1. New Primary School in Mulgoa Rise – 1-23 Forestwood Drive – Glenmore Park

ptc. has been engaged by Richard Crookes Construction on behalf of School Infrastructure NSW (SINSW) to address comments received following the submission of the State Significant Development Application (SSDA) for the proposed development of a new primary school located at 1-23 Forestwood Drive in Glenmore Park. The Transport and Traffic Assessment dated 20 August 2021 and submitted as part of the SSDA was prepared by **ptc.**

2. Council Comments

Figure 7 – Bus Zones at Pedestrian Holding Area

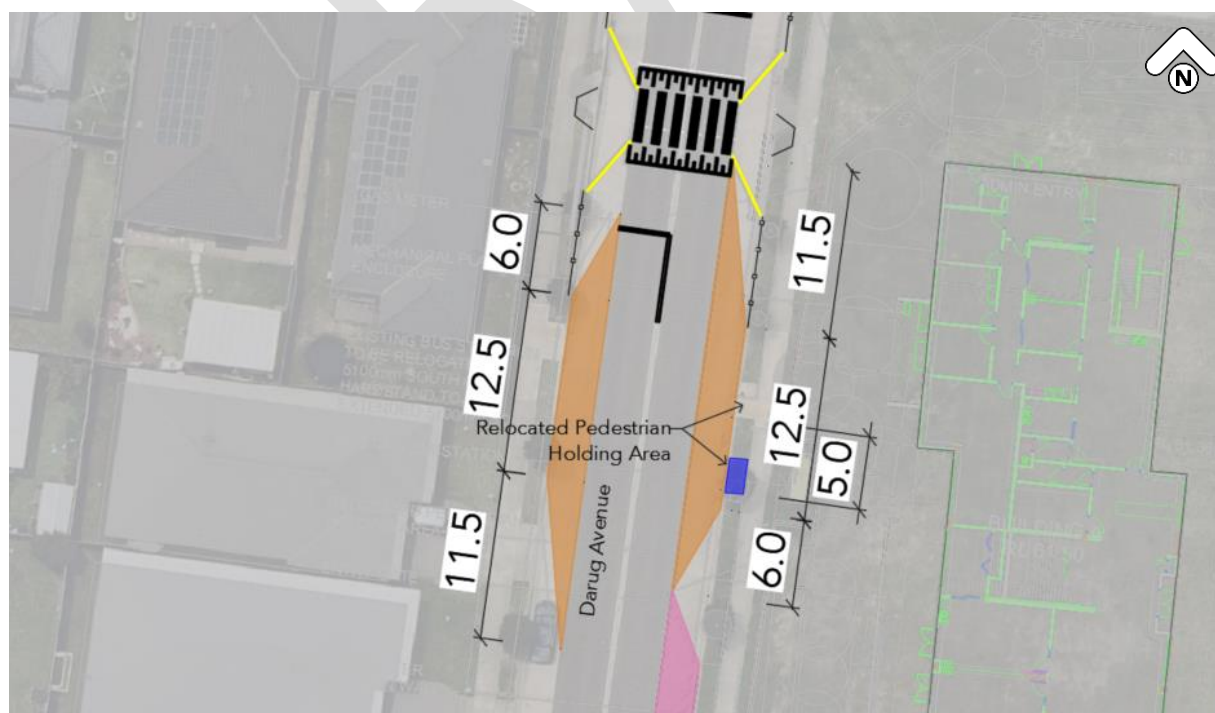
iii) The existing bus stop boarding points should be related to align with the adjust 'Bus Zone' boarding point location and replaced with Council and DDA complying bus stop boarding points and bus shelters to Council satisfaction. Consultation shall be undertaken with Busways, TfNSW Bus Section and effected nearby residents and their acceptance or other comments provided with the application.

It is not proposed to relocate the boarding point on the western side of Darug Avenue, as there is no requirement to do so. Refer to Section 2.2 for the relation between the zebra crossing and the bus stops.

The eastern boarding point has already been addressed in the SSDA TTA, where it was relocated south by 5m due to the zebra crossing design.

The location of bus stops and boarding points at Darug Avenue are presented in Figure 7.

Figure 8 – Proposed Signages at Forestwood Drive and Parkway Avenue bend

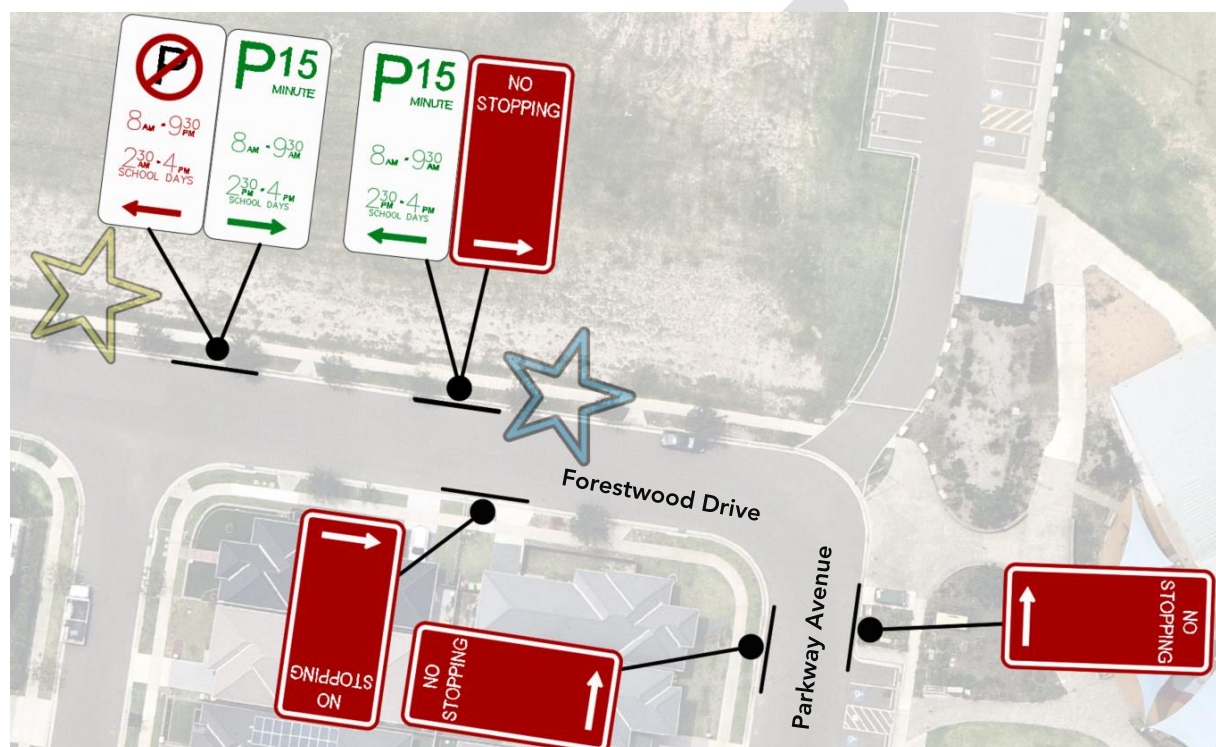
The ‘No Stopping’ zone along the northern side of Forestwood Drive should extend along the bend to the start of the 90 degree parking in Parkway Avenue.

The location of the ‘No Stopping’ sign has been amended as shown in the following figure. A detailed amended signage plan is presented in **Attachment 1**.

Figure 9 – Proposed Pedestrian Fencing at Darug Avenue and Deerubbin Drive intersection

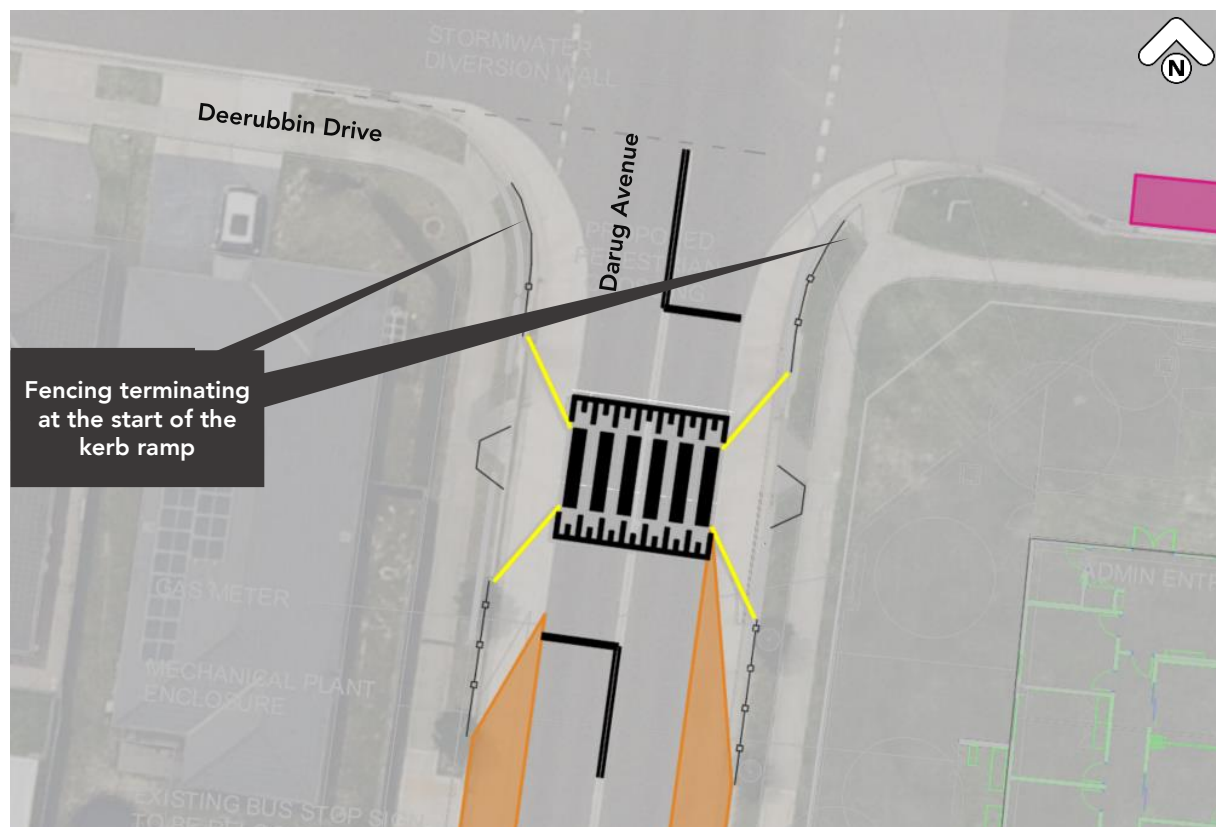
The proposed fencing at the corner of Darug Avenue and Deerubbin Drive should terminate at the start of the kerb ramp to cross Deerubbin Drive.

The fencing at the corner of Darug Avenue and Deerubbin Drive has been amended to terminate at the start of the kerb ramp, as shown in Figure 9.

Figure 10 – Proposed Zebra Crossing Design

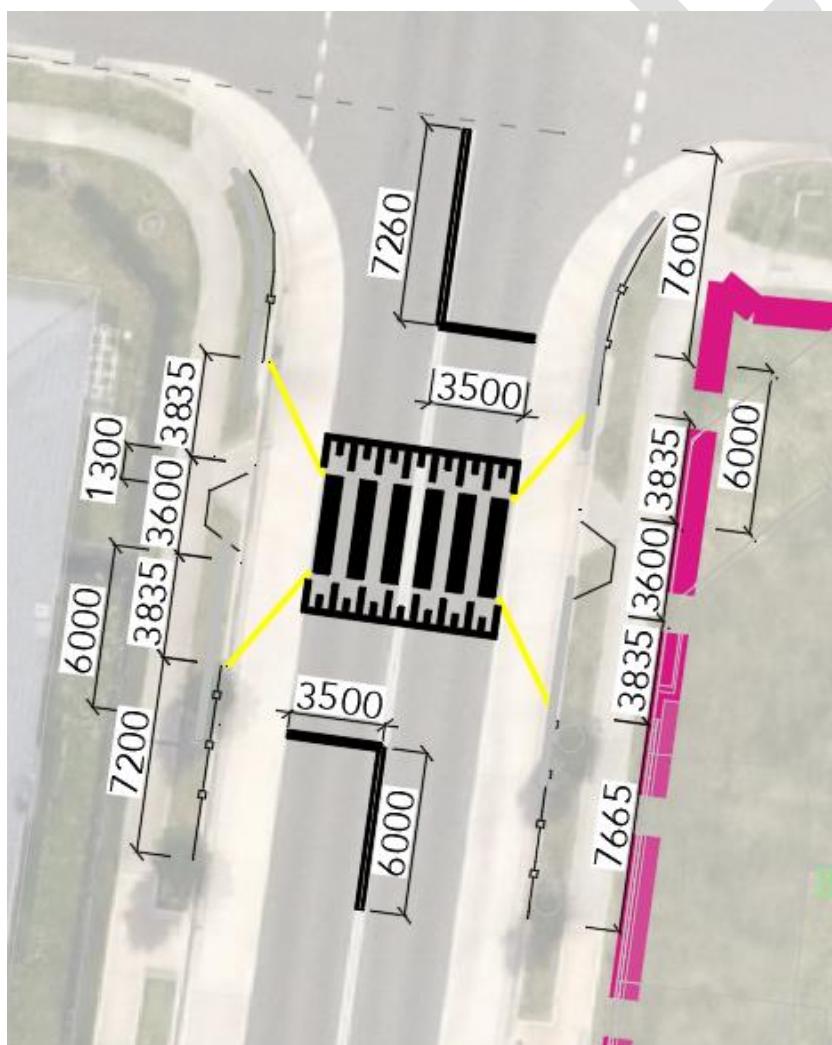
The proposed at grade pedestrian crossings must be raised and conform to Council's general design for raised combined pedestrian / children's crossings. The crossings must be a combined raised pedestrian crossing and children's crossing with raised shoulder medians, no fencing on the shoulders as shown proposed, with red and white poles, approach TF holding lines, children crossing flags and No Stopping zones complying with TfNSW guidelines.

As per information provided to the authorities and discussions held as part of the TWG meetings, there is a flooding issue within the surrounding roads which prevents implementing any raised infrastructure within the carriageways (refer to documents prepared by Woolacotts: the Overland Flow Flooding Summary dated 27 July 2021 and the Flood Impact Assessment dated 22 October 2021).

A revised at grade zebra crossing design is shown in the below figure and in **Attachment 1**, with the yellow lines representing fencing (or any other structure i.e. bollards that would be deemed acceptable) to imitate the kerb build outs. This is so that the impact on the water flow within the carriageway is minimised.

Figure 11 – Proposed Pedestrian Fencing at Darug Avenue

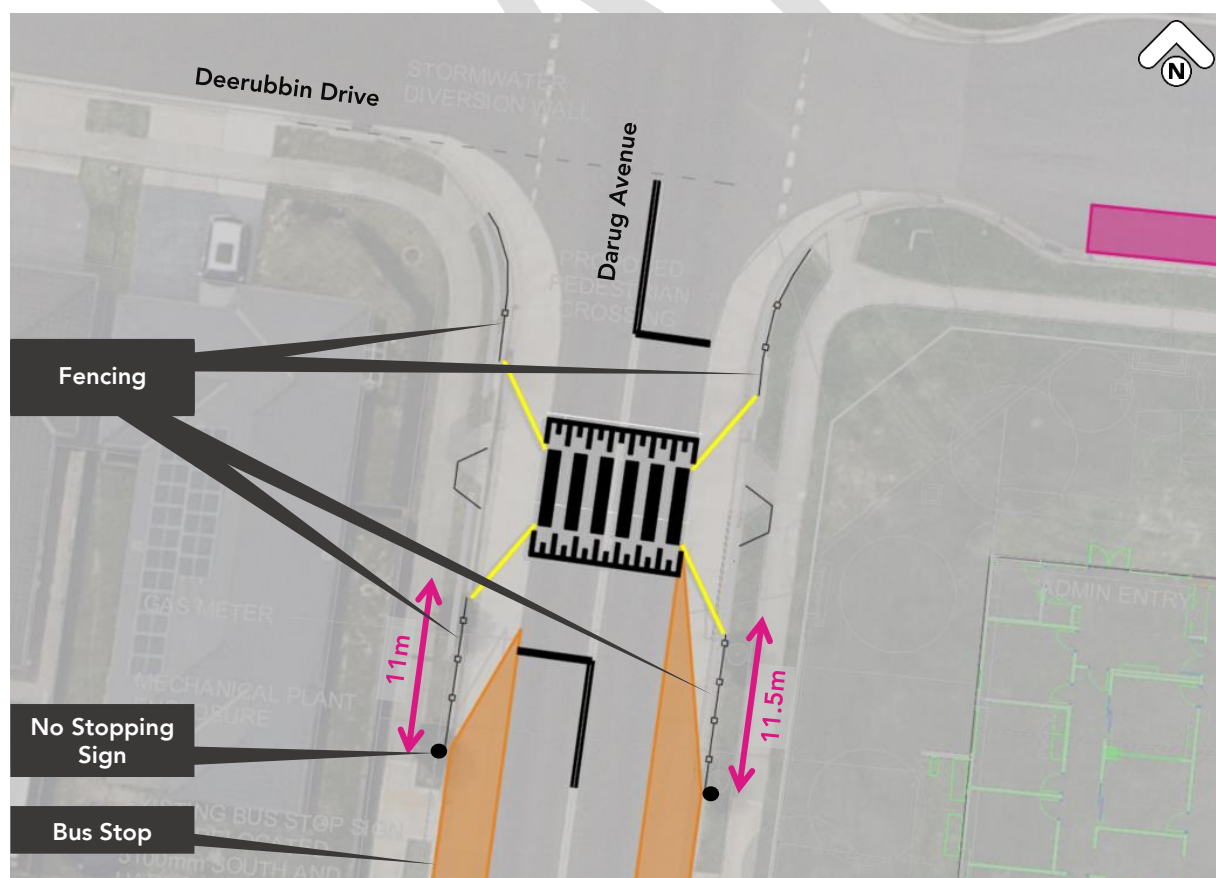
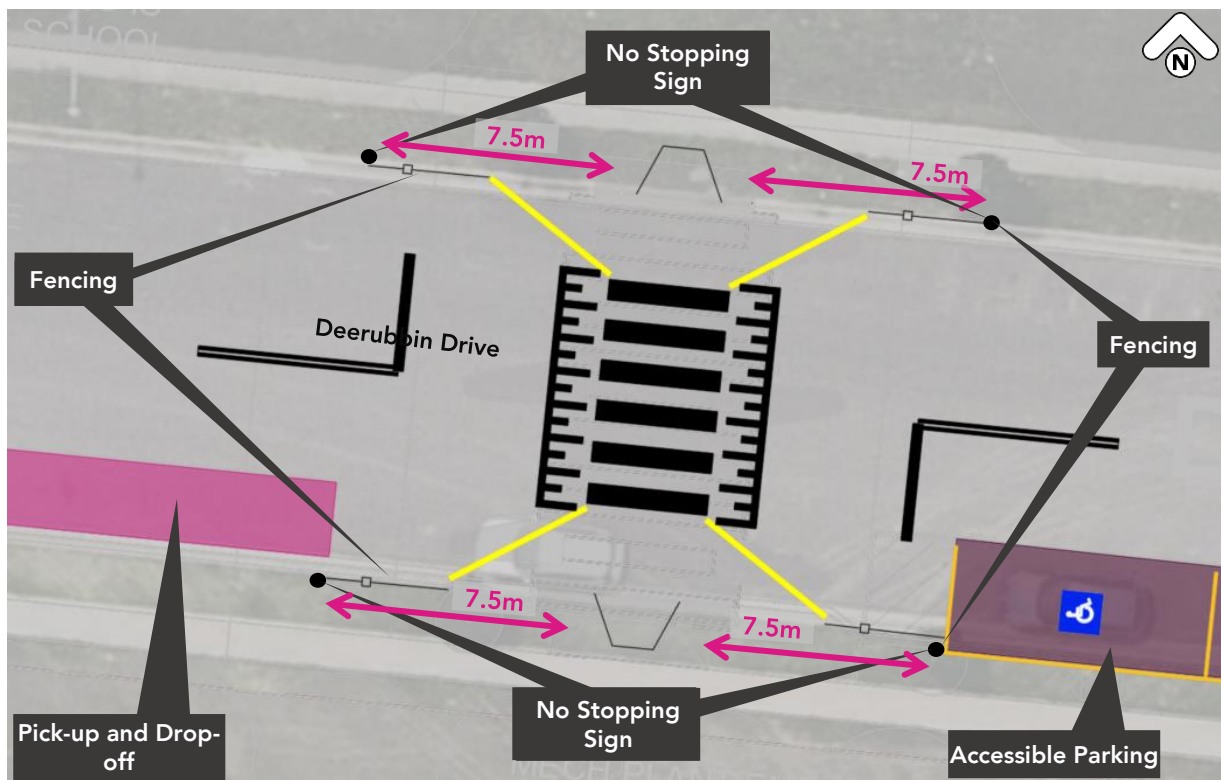
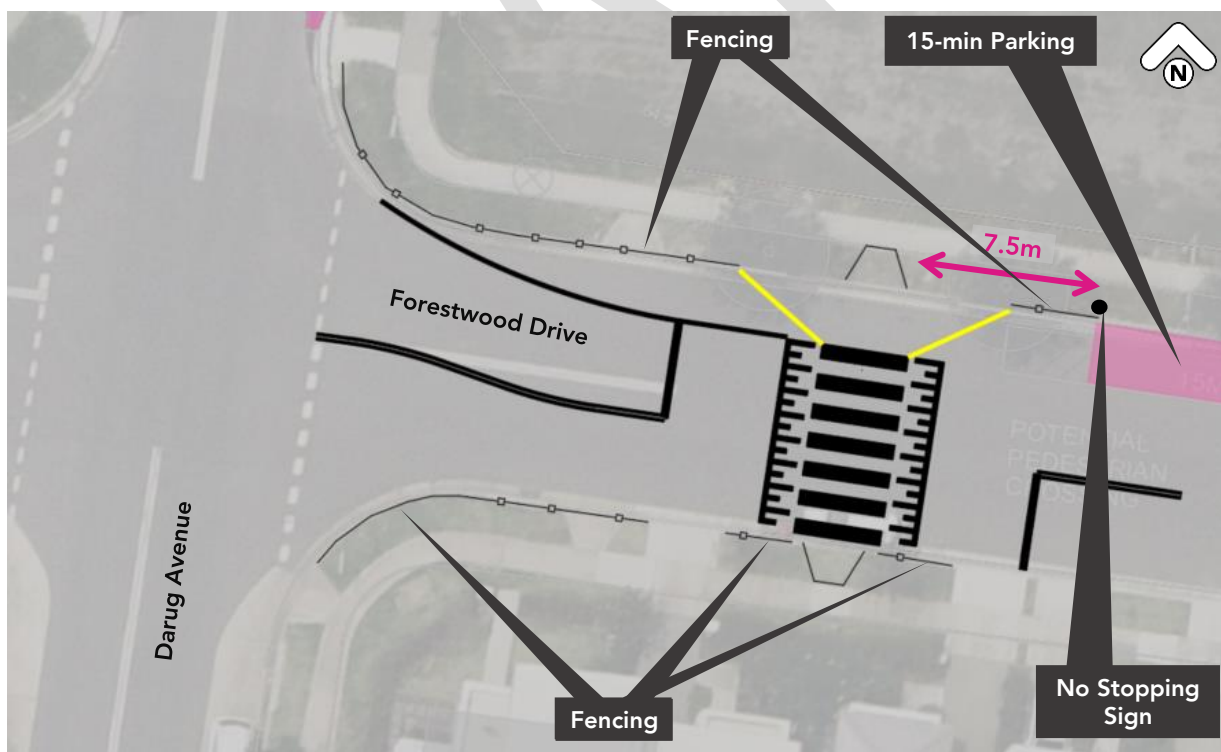
There should also be pedestrian fencing provided on the verge at the back of the kerb, at the crossing 'No Stopping' zones on each side to direct pedestrian to the crossing.

Fencing is proposed on the verge at the back of the kerb from the zebra crossings to the pram ramps at intersections, from zebra crossings to 'No Stopping' or a distance of 7.5m at the midblock, at the start or end of bus bays and up to the driveways of the adjacent properties. The proposed fencing at Darug Avenue, Deerubbin Drive and Forestwood Drive are presented in Figure 11, Figure 12 and Figure 13 respectively.

Figure 14 – Vehicle Holding Area at Darug Avenue

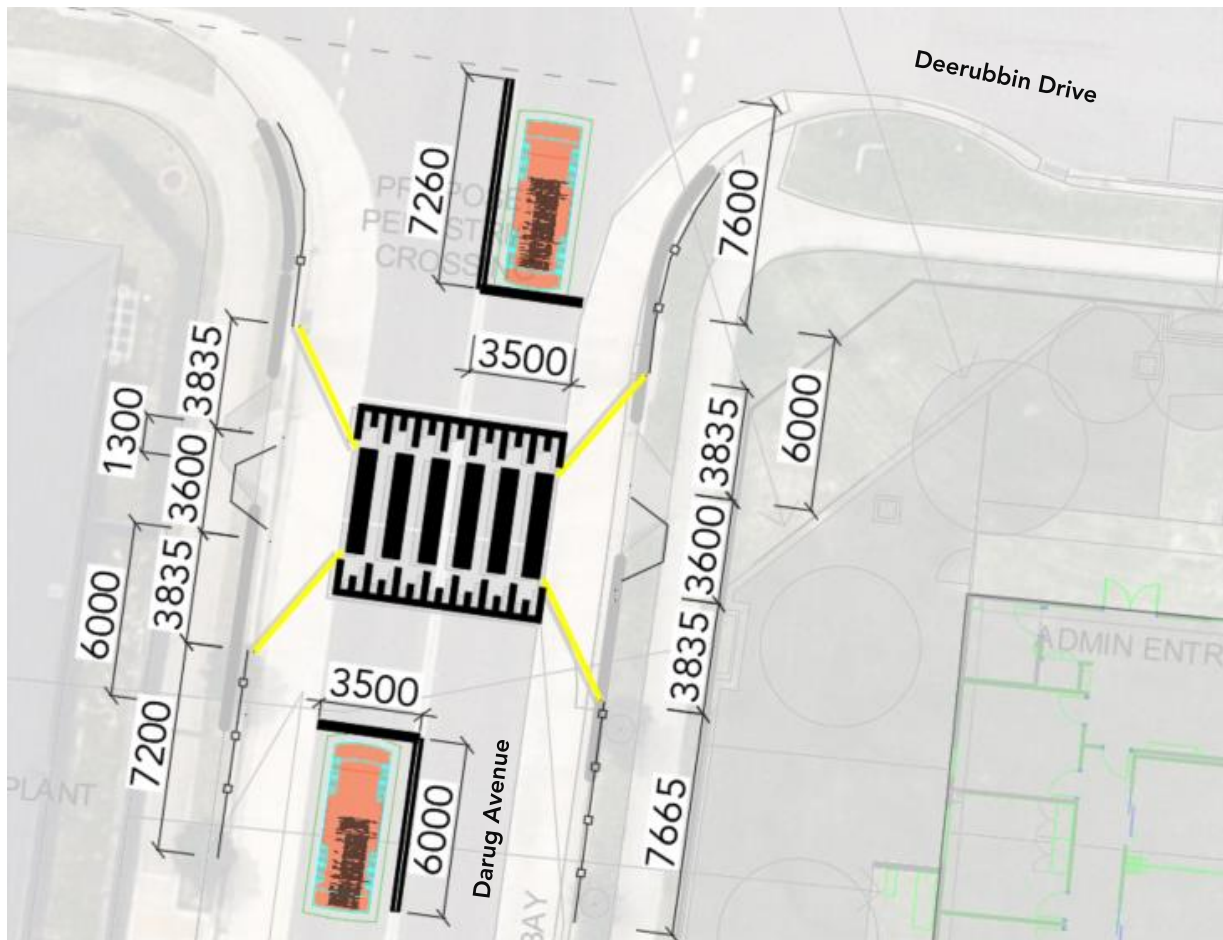
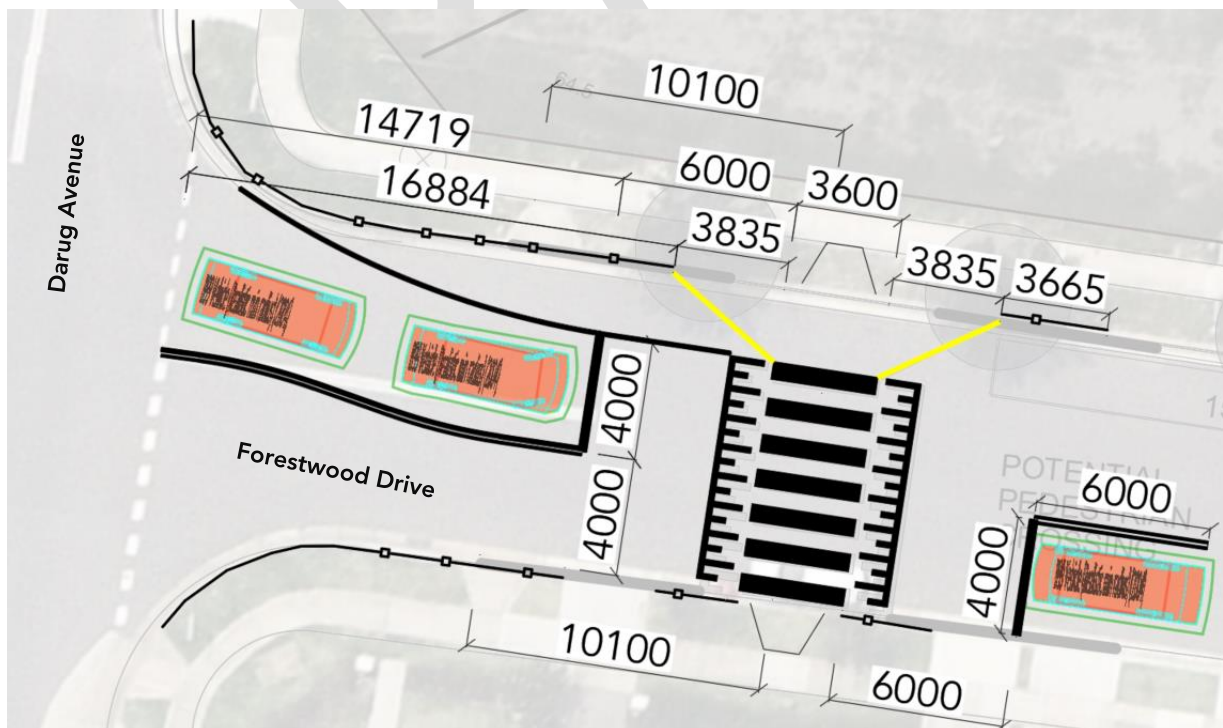
The proposed crossing in Darug Avenue and in Forestwood Drive should be relocated to provide at least 13m of queuing clearance (to allow for two cars or one HRV or bus) from the Deerubbin Drive and Forestwood Drive through traffic to the TF holding line which should be located 6m from the edge of marked pedestrian crossing.

The zebra crossings have been relocated following the detailed design and they are now located as follows (refer to Figure 14 and Figure 15):

- 7.6 m long vehicle holding area is provided on Darug Avenue allowing for 1 car to wait, and
- 14.7m long vehicle holding area is provided on Forestwood Drive allowing for 2 cars or 1 truck to wait.
- Additional 6m distance from the zebra crossing to the stop line is provided at both crossings, as per the guidelines for children's crossing.

Lengthening the distance of the Darug Avenue crossing to a distance of 13m from the intersections is not seen as required and is not recommended for the following reasons:

Figure 16 – Walking Catchment and Student Population

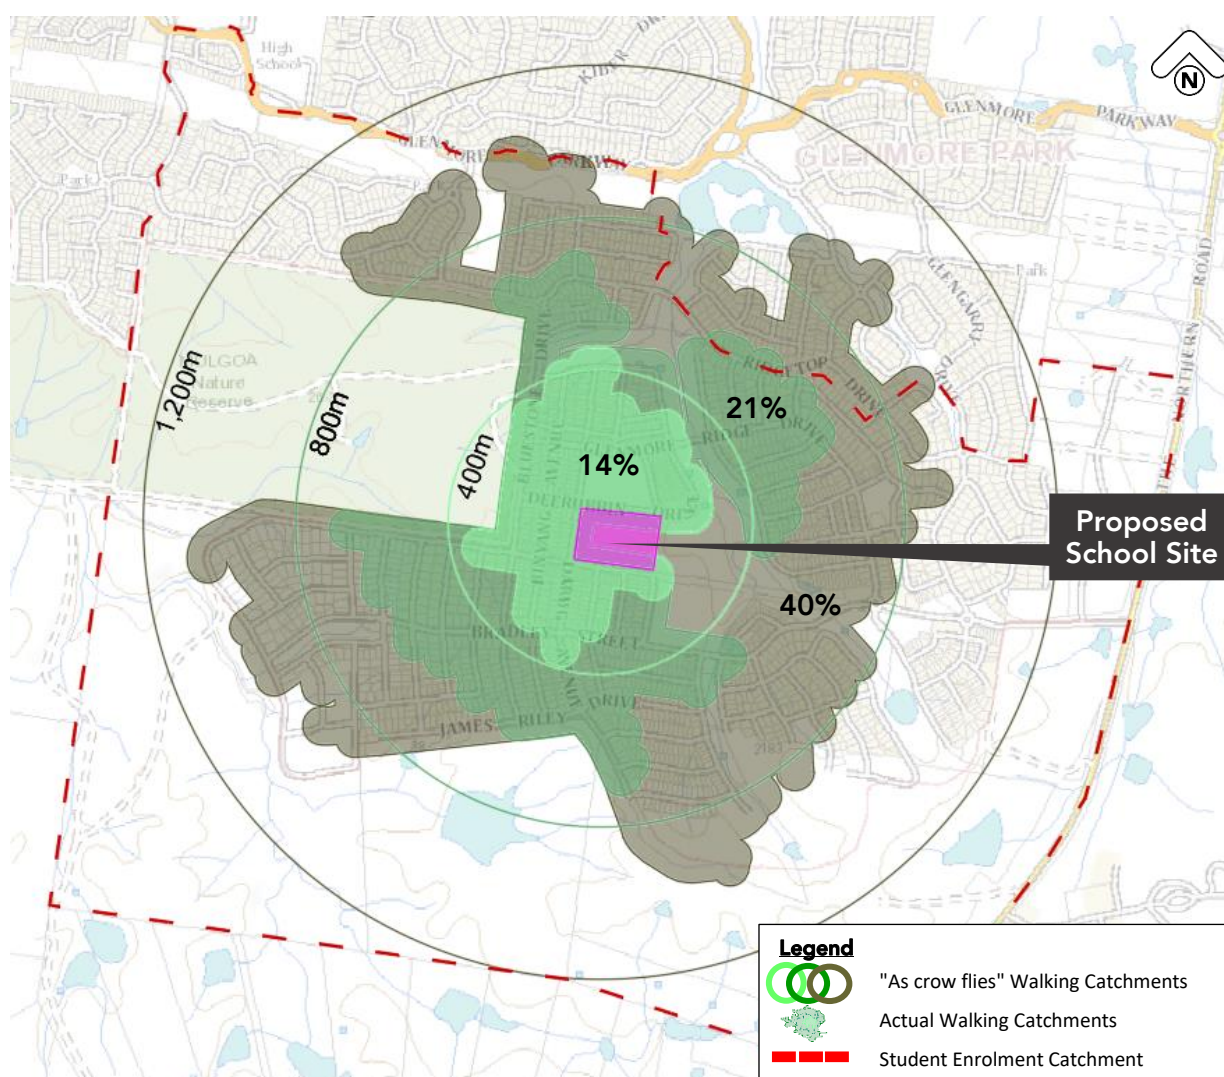
The Traffic Report - School Transport Plan indicates mode of travel will be:

In any case, the "as crow flies" and actual 400 / 800 / 1200m walking catchments are presented in Figure 16, which also outlines the small enrolment catchment. Within the enrolment catchment, 14% of students reside within the 400m walking catchment, 21% within the 401m - 800m catchment and 40% within the 801m - 1200m catchment. Additionally, the surrounding area has been well developed with reasonable pedestrian infrastructures including footpaths, shared paths and pram ramps.
